**DEFENSE NUCLEAR FACILITIES
SAFETY BOARD**

July 25, 2024

Staff Report

Safety Posture of the Principal Underground Laboratory for Subcritical Experimentation and Associated Major Modification Projects

Figure 1. *Fault distribution within PULSE [10]. Solid red lines indicate observed faults and dashed red lines indicate inferred faults.*

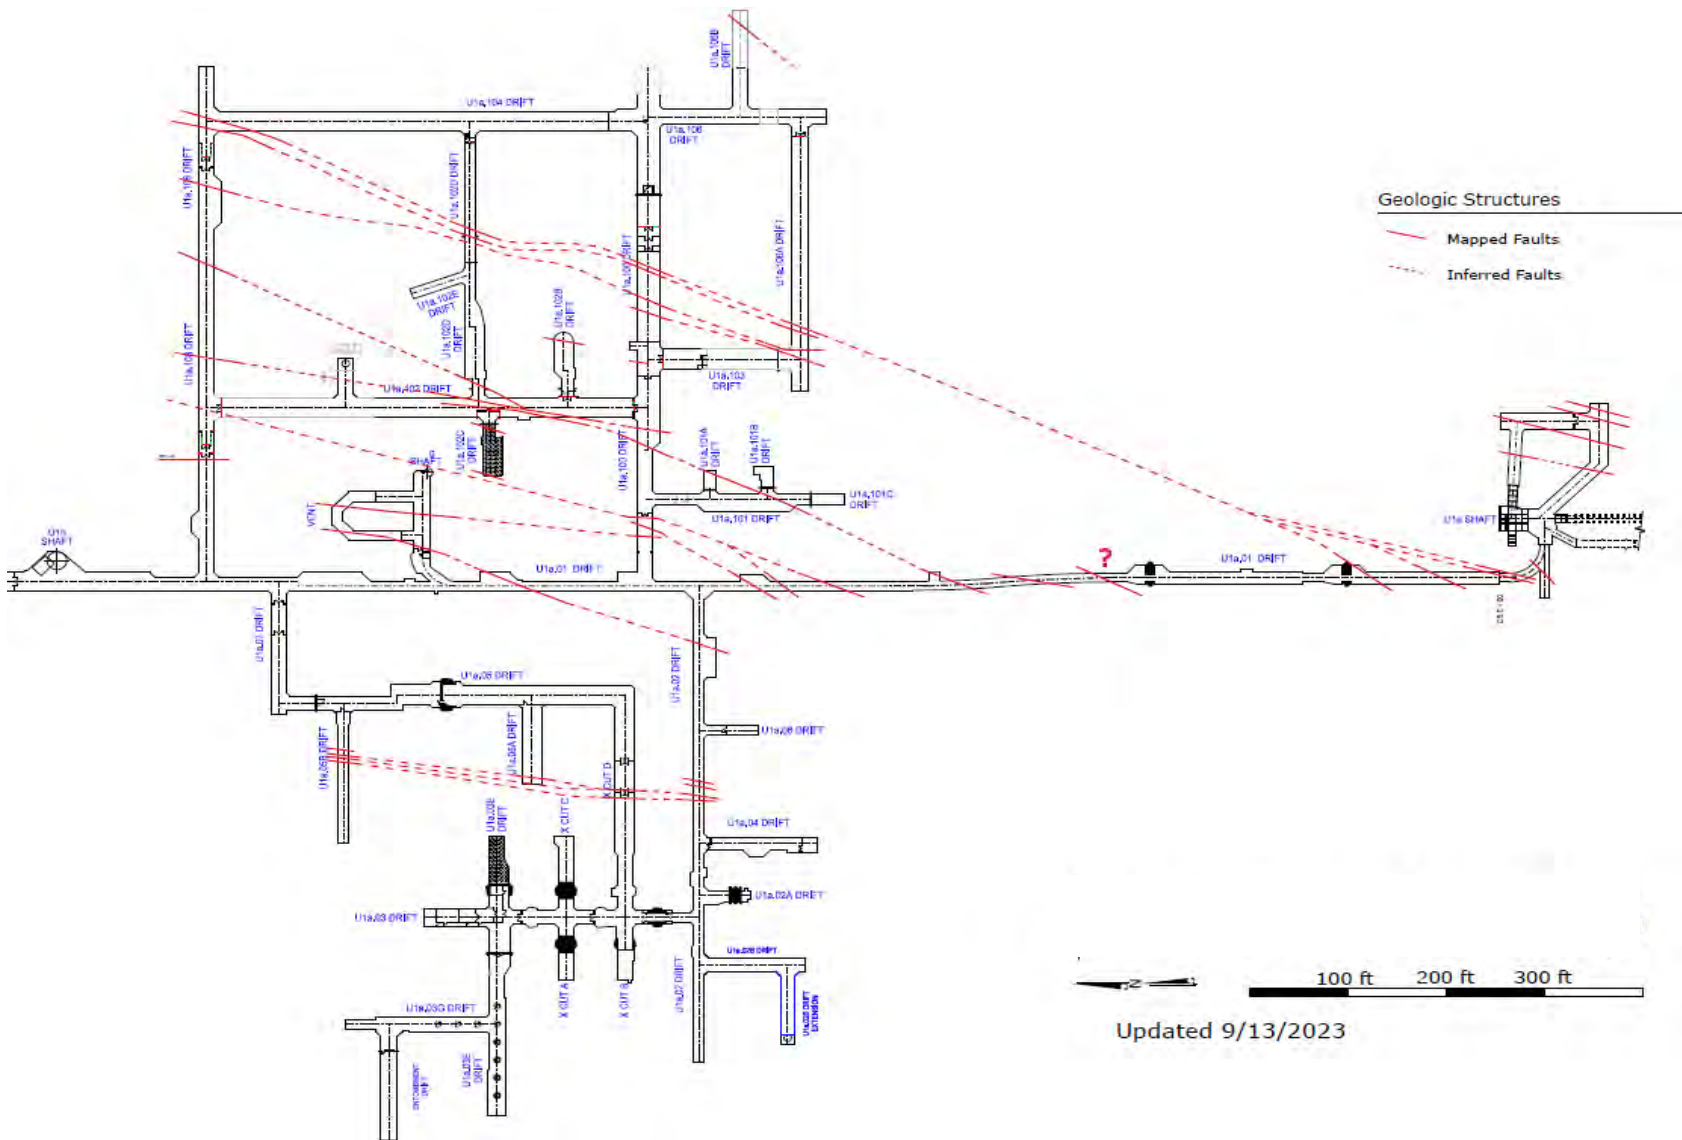
Uncharacterized Seismic Faults in PULSE—Seismic faults are extensively exposed within the PULSE tunnels with more than 50 individual locations based on the fault distribution map (Figure 1). Although these faults are dispersed across various tunnel sections and not directly interconnected, they are part of the fault system, as some can be linked to form longer faults based on their orientations and fault types. NNSS geologists currently consider the faults present in PULSE to have occurred in the Tertiary period⁴ instead of the Quaternary period. Evidence from NNSS geological reports [6–9], along with observations during the staff team’s walkdowns, indicate that the faults within the PULSE tunnels could be younger and potentially be Quaternary.

Figure 2. *Potential impact of faults within PULSE, displacing drifts and triggering earthquake vibrations.*

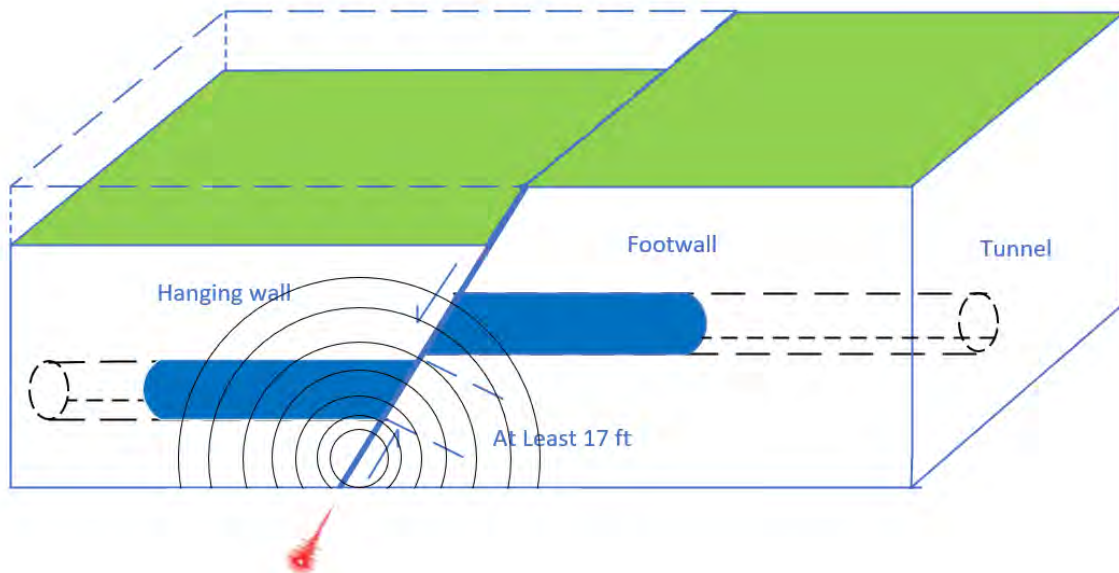
The safety design basis documents for the ECSE projects do not analyze a fault displacement hazard scenario. NNSS personnel consider this scenario to be bounded by the analyzed scenario in which a seismic event results in overhead equipment falling onto a subcritical experiment package [2]. The safety design basis documents credit the shipping container to protect the subcritical experiment. The magnitude of a fault displacement is typically proportional to the dimension of the faults [11]. Given that the dimensions of the faults in PULSE are uncharacterized, the potential magnitude of the fault displacement event is unknown but could potentially be 17 feet or greater (Figure 2). The shipping container may not be able to fully protect the subcritical experiment from a severe displacement. As a result, the ECSE safety basis documentation should analyze this event separately as a unique hazard.

Because the PULSE faults are not included in the USGS database, all NNSS facilities (e.g., DAF) may be underestimating the seismic hazard. Also, important NNSS infrastructure, such as highways and electrical transmission lines, could be potentially severed due to fault displacement.

Figure A-2. *NNSS Photo [7] shows that a nearly vertical fault displaced sedimentary layers. Fault line is indicated with a red line. Note that the nearly horizontal sedimentary layer with gravels at the bottom left was discontinued near the red line.*

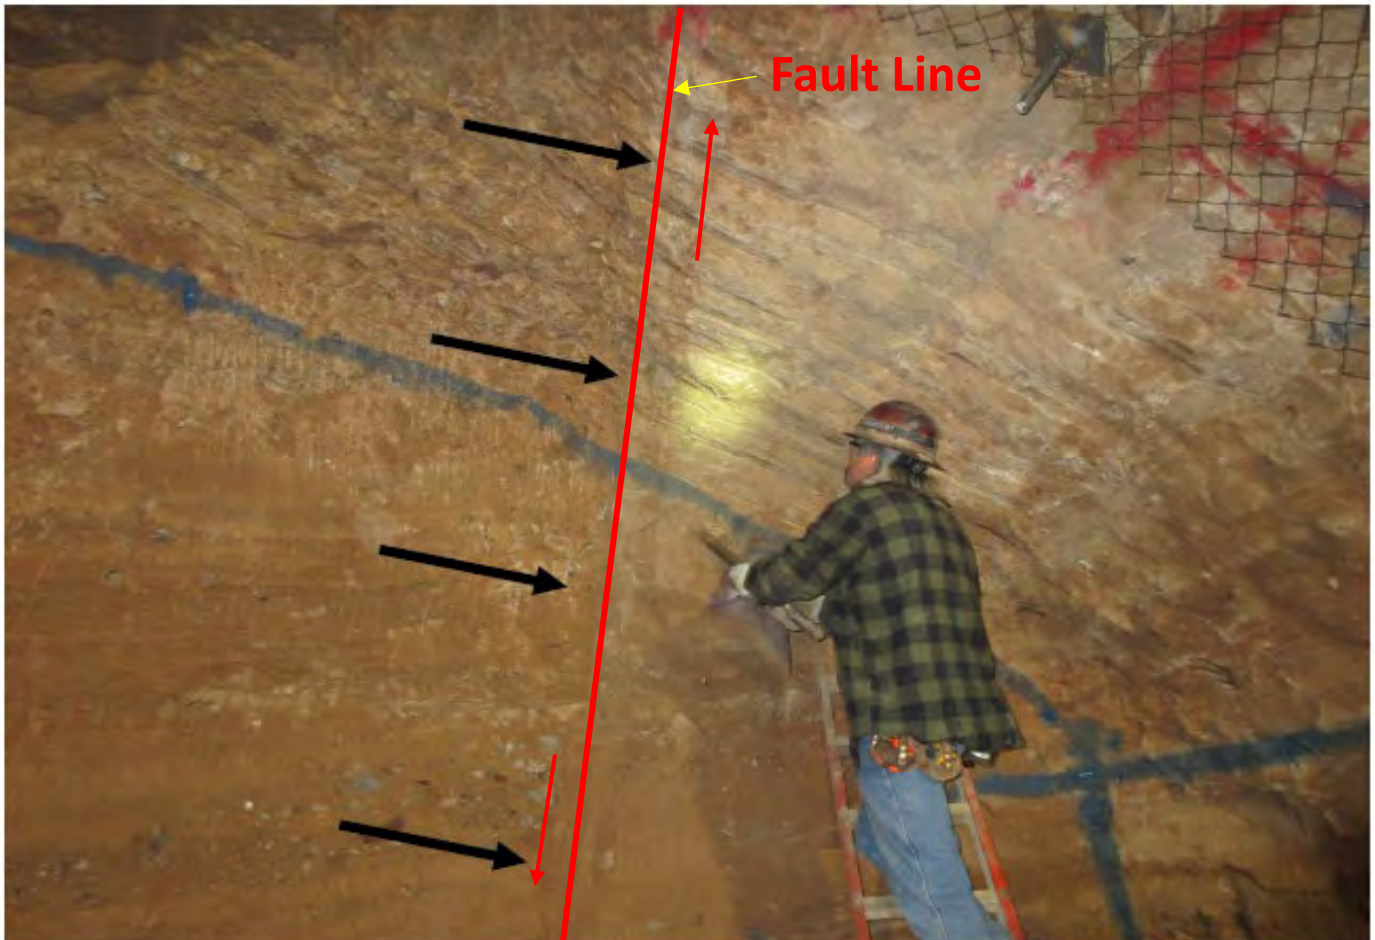
Even if the ash layer was deposited in the Tertiary period, that would not mean faulting necessarily occurred in the Tertiary period. This is because evidence from NNSS geological reports [6–9], along with observations during the staff team’s walkdowns, indicate that the faults within PULSE not only displaced the ash layer but also displaced alluvium layers younger than the ash layer, extending beyond the tunnel ceiling. These faults could terminate anywhere between immediately above the tunnel ceiling and the ground surface. In undisturbed sedimentary layers, the younger sedimentary layers are closer to the surface. This suggests that the age of the faults within the tunnel could be younger than the age of the tunnel-level deposits they displaced and older than the present ground surface, which they did not penetrate.

Figure A-3. *NNSS photo [7] shows fault slickensides indicating past rapid movement along the fault.*

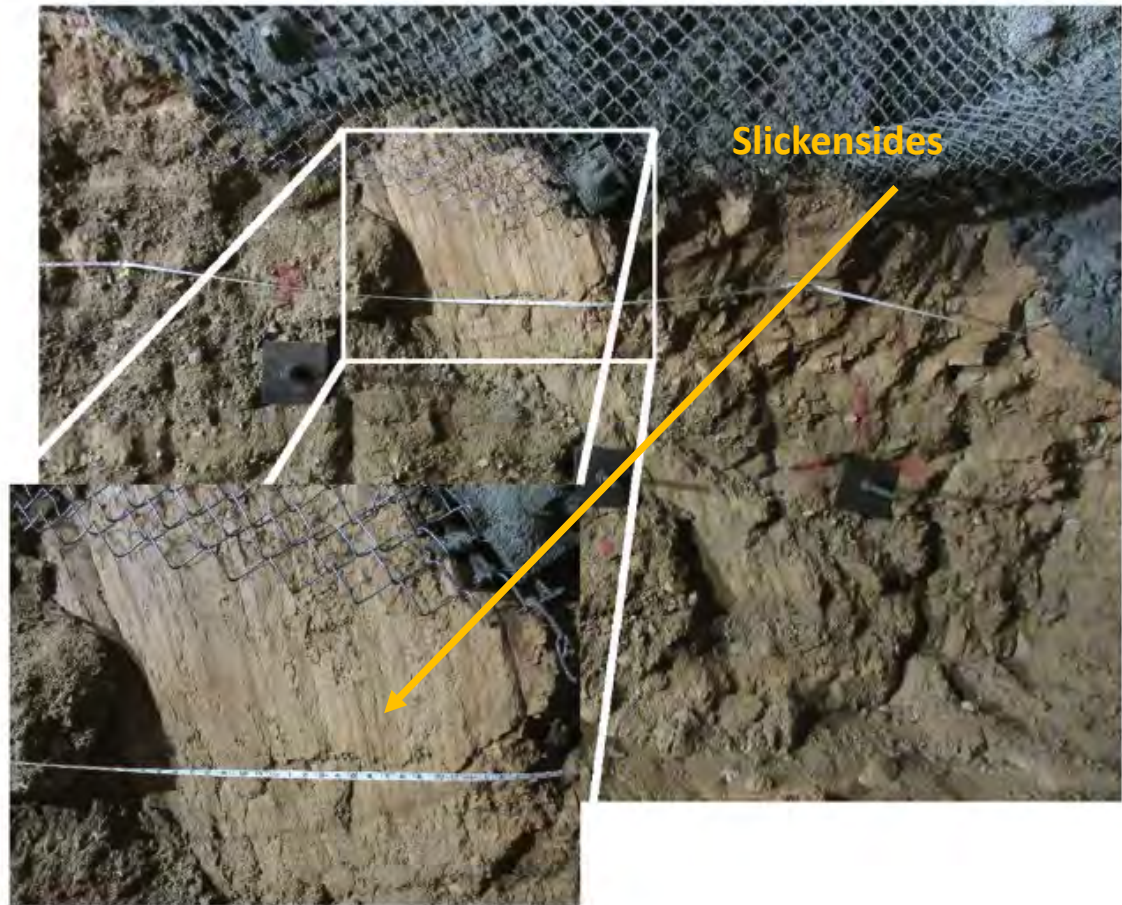
A NNSS geological report published in 2003 estimates that the faults exposed at the tunnel level (about 900 feet beneath the surface) also displaced the layers closer to the surface at a depth of around 450 feet [6]. This means that the faults are from an even younger Quaternary age because the layers closer to the surface are generally younger. However, NNSS geologists

now consider this report inaccurate because the displacement at the shallow depth was inferred rather than directly measured. NNSS geologists plan to update this report.

Figure A-4. *Potential impact of faults within PULSE, displacing drifts and triggering earthquake vibrations.*

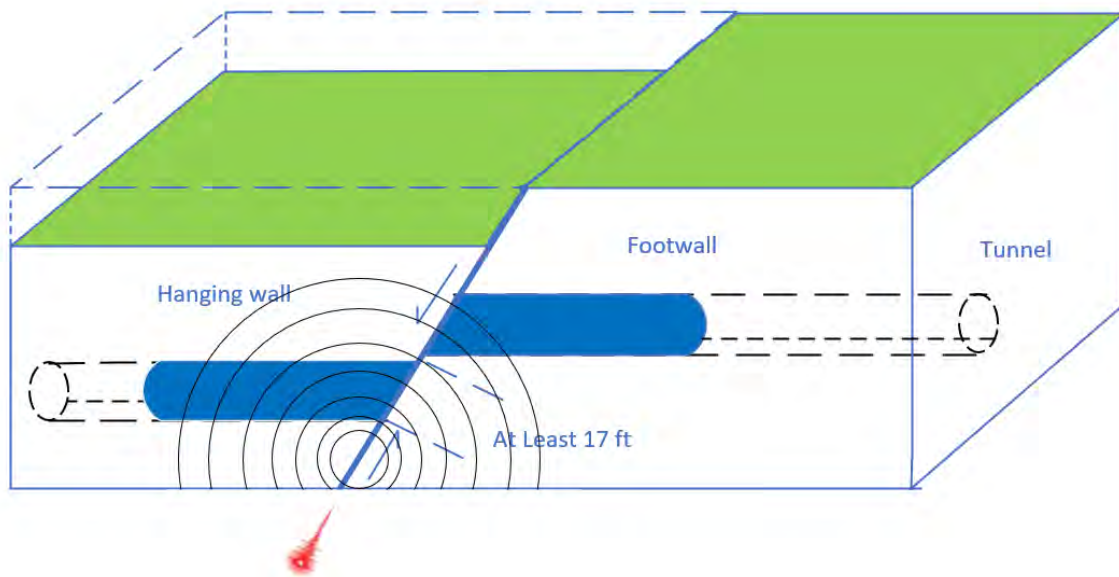
The magnitude of the fault displacement is typically proportional to the dimension of the faults [11]. Given that NNSS personnel have not characterized the dimensions of the faults in PULSE (e.g., the faults could extend to the north or south for many miles), the potential magnitude of the fault displacement event is unknown. Additionally, normal faulting events could displace the underlying layers, which could consist of various hard rocks. If a more severe displacement were to occur, then the shipping container may not be able to fully protect the

subcritical experiment (Figure A-4). As a result, the ECSE safety basis documentation should analyze this event separately as a unique hazard.
